Access Compliance Report

Public Rights-of-Way

| Intersection ID: 15205 | Main Street: CHEROKEE_RD | Cross Street: FENTON_PL | Location: SW |
| ADA ID: A5CB8B43ABD9 | Ramp Type: Directional1 | Initial Pass/Fail: Fail | Overall Compliance: No |

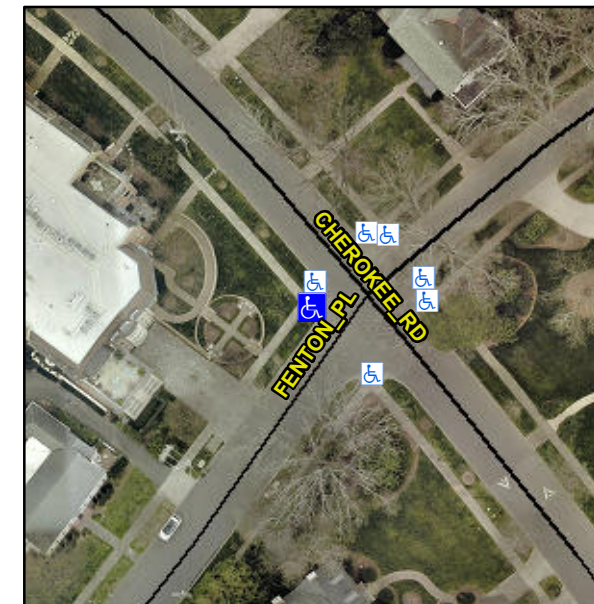
R304.5.1, R304.2.2, R304.5.3

| Compliance | Description | Data | Compliance | Description | Data |
|------------|-----------------------|-------|------------|-----------------------------|------|
| No | Ramp Width (in) | 47.0 | N/A | Grade Break Slope (%) | 0.0 |
| No | Ramp Slope (%) | 9.4 | N/A | Grade Break XSlope (%) | 0.0 |
| No | Ramp XSlope (%) | 2.4 | | | |

Remove & Replace Entire Ramp.
